FEDERAL PROJECT NO. TAP-9901(649)
BPS PROJECT NO. 2018-40-084

ADDENDUM NO. 1

LOUISIANA CALM STREETS

DATE: **9/21/21**

SHEET 4 OF 116

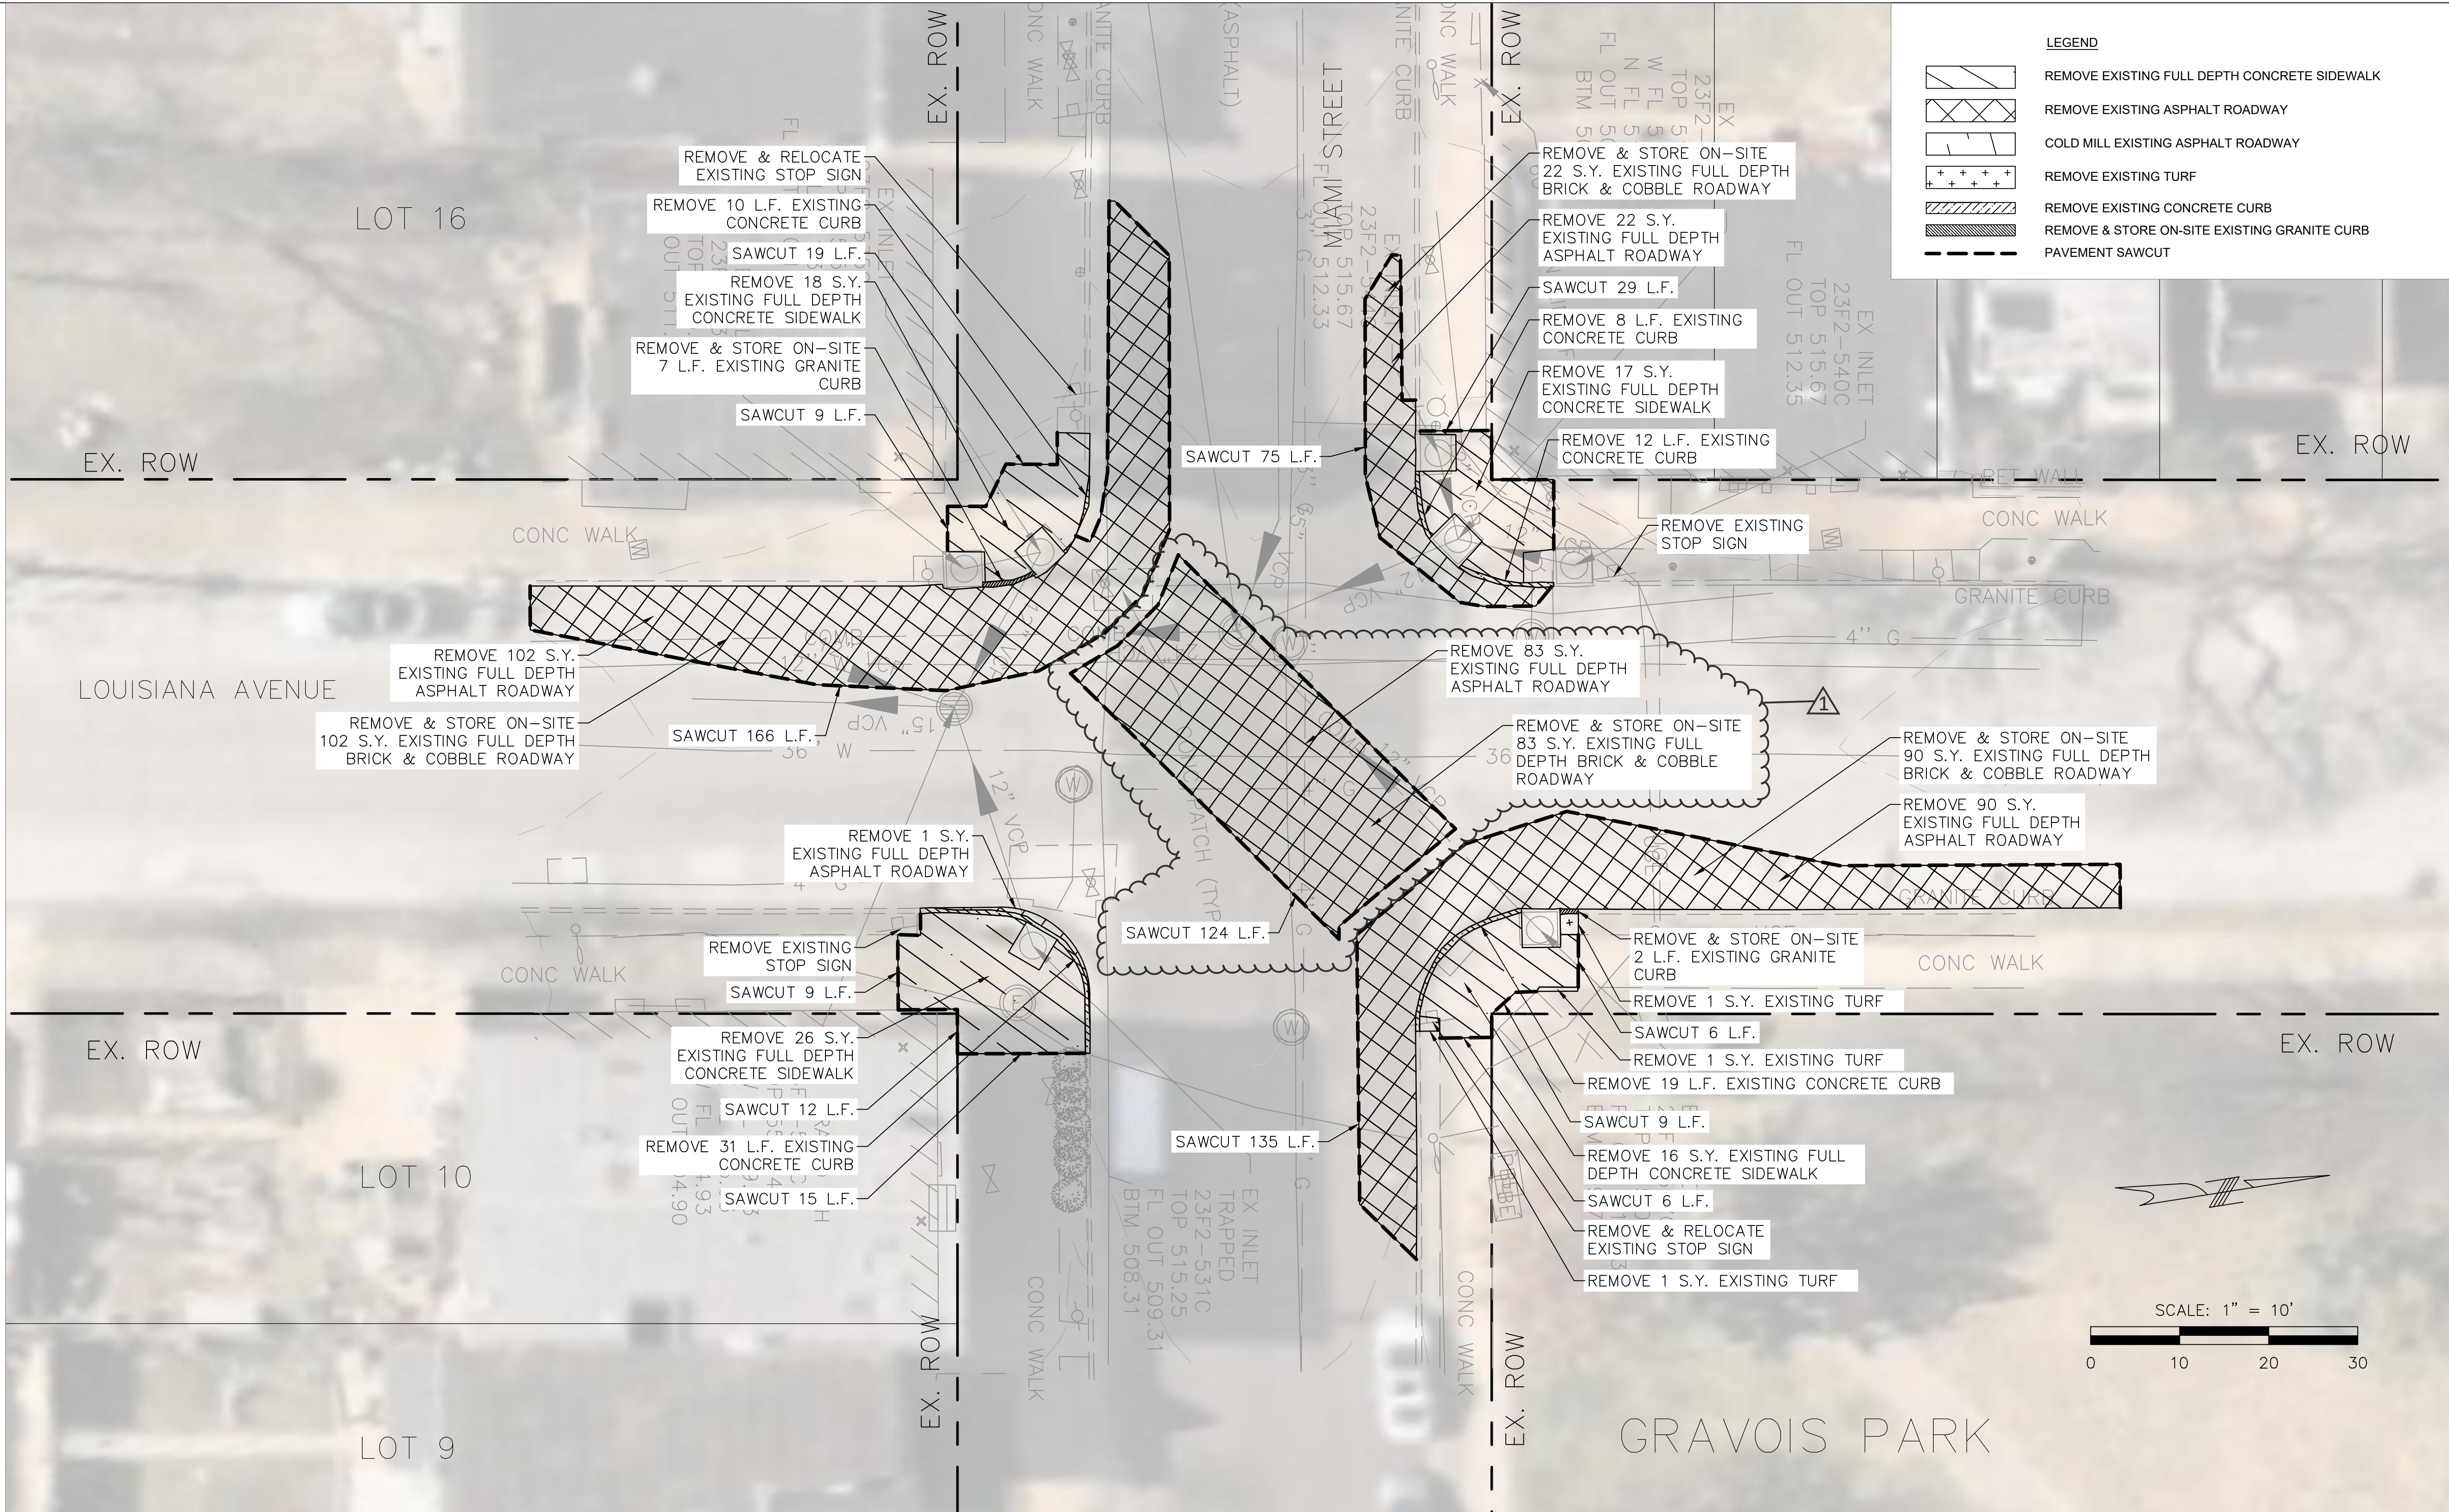
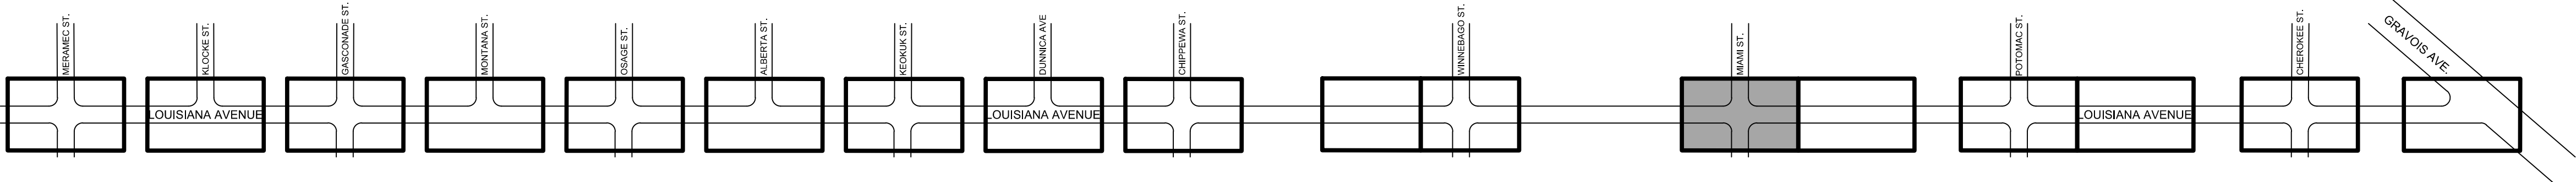
- **Plan Sheets 3A and 4; Revised:** Replace sheets 3A and 4 with the two attached plan sheets. Plan sheets have been revised to update quantities of 6 bid items.
- **Plan Sheet 19 and 21; Revised:** Replace sheets 19 and 21 with the two attached plan sheets. Plan sheets have been revised to delete reference to cold mill for the speed tables at Miami and at Potomac. Removals for diagonal speed tables shall be sawcut and full-depth pavement removal. Removal costs to be incidental to "Removal of Improvements". See Q&A for additional details.
- **Plan Sheet XX; Add:** Add the attached plan sheet "Sheet XX of 116, Concrete Speed Hump Details" to the plans.

SHEET XX OF 116

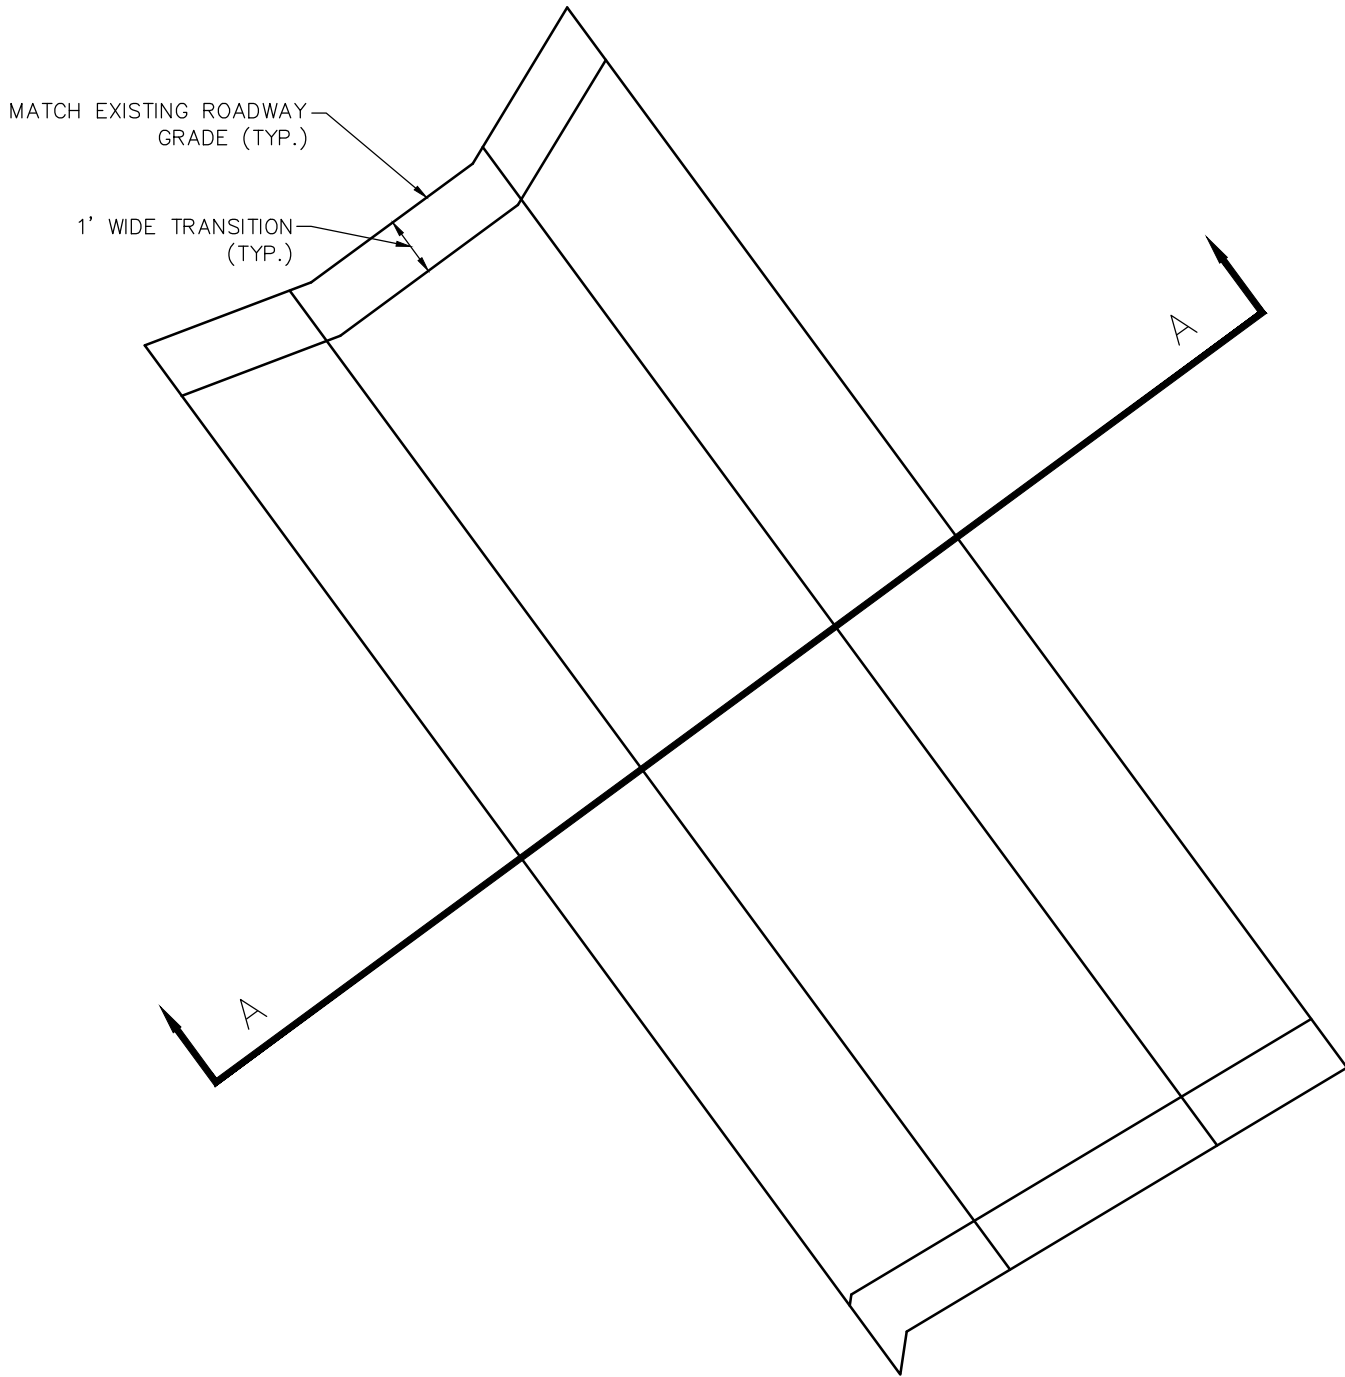
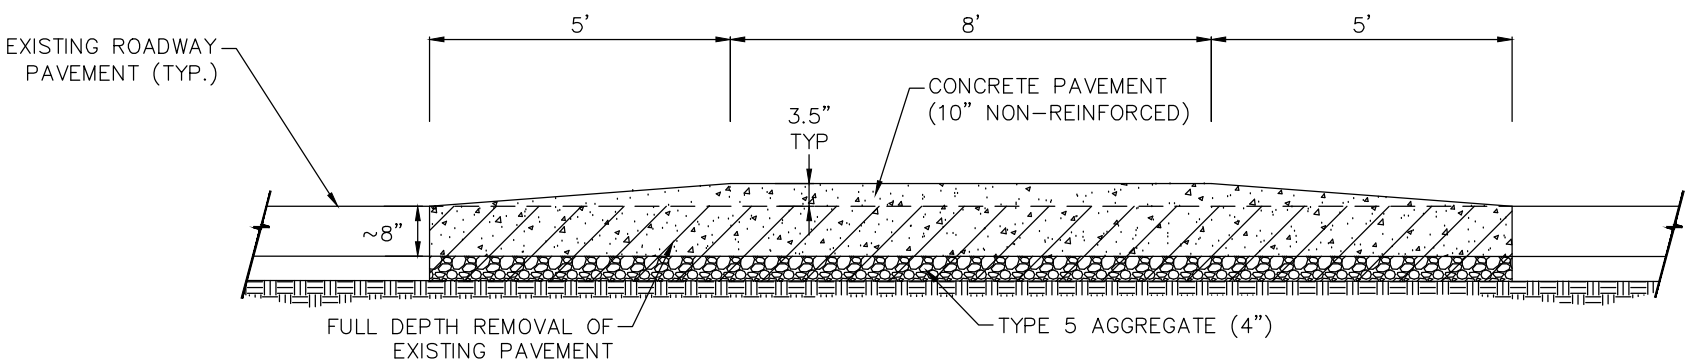
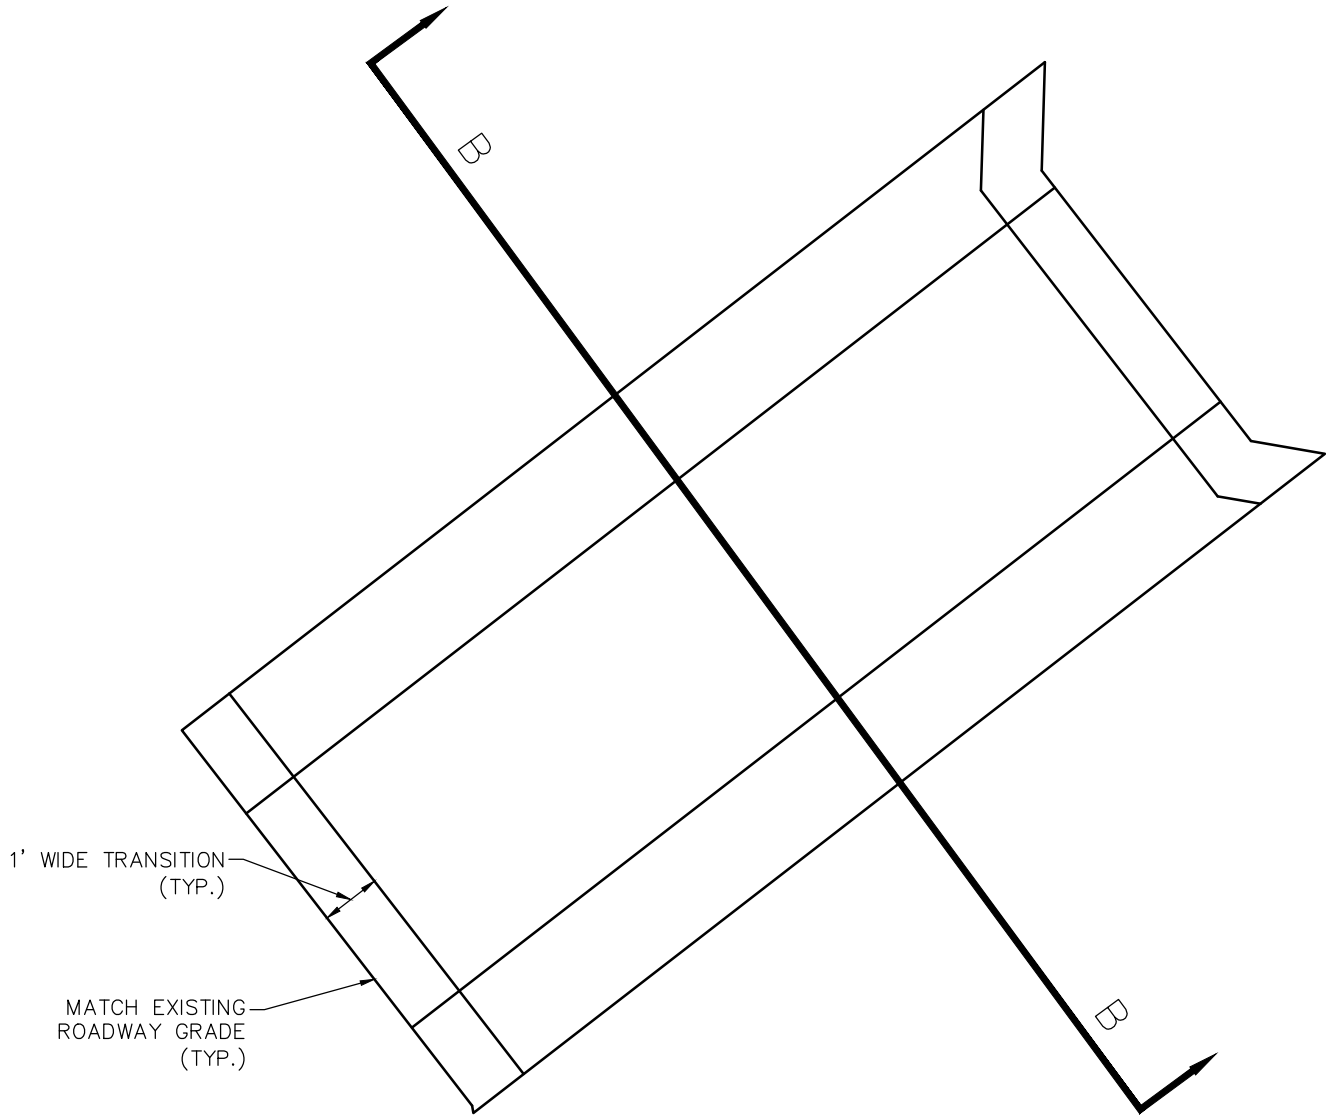
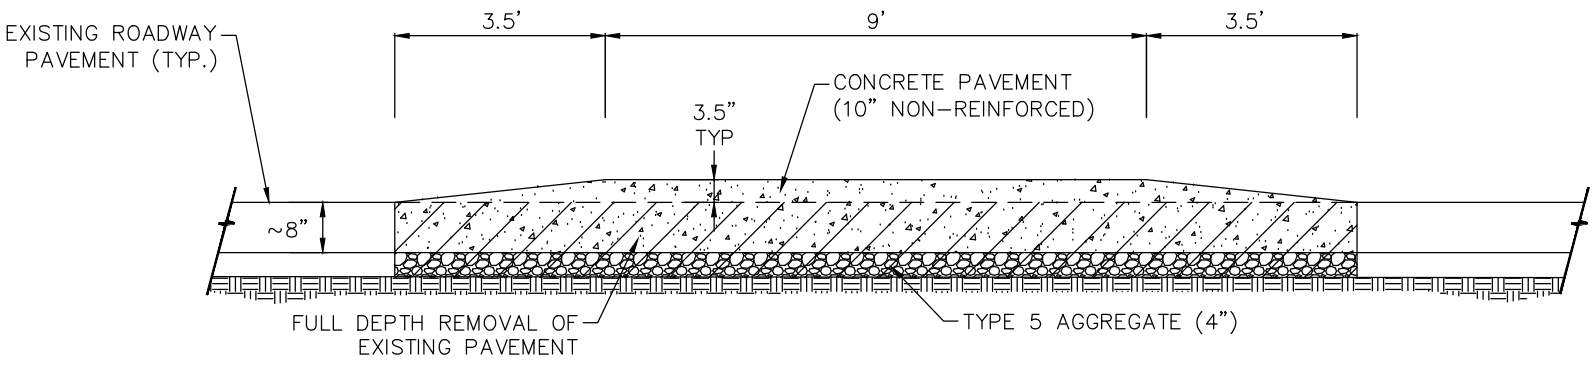
- Q:** Please provide details for concrete pavement 10" (Speed Bumps – 2 ea.), Item #15.
- A:** Detail is provided on new plan sheet XX, included in this addendum. The thickness of pavement for the speed tables varies from 8" to 11.5". Regardless of thickness, the entirety of the speed tables will be measured to the nearest square yard and paid for at the unit cost of "Concrete Pavement (10" Non-Reinforced)". Speed tables shall be installed on 4" aggregate base, which shall be measured to the nearest square yard and paid for at the unit cost of "Type 5 Aggregate for Base, 4 Inch". No separate payment will be made for pavement sawcutting or full-depth pavement removals, the cost of which shall be incidental to the line item "Removal of Improvements".
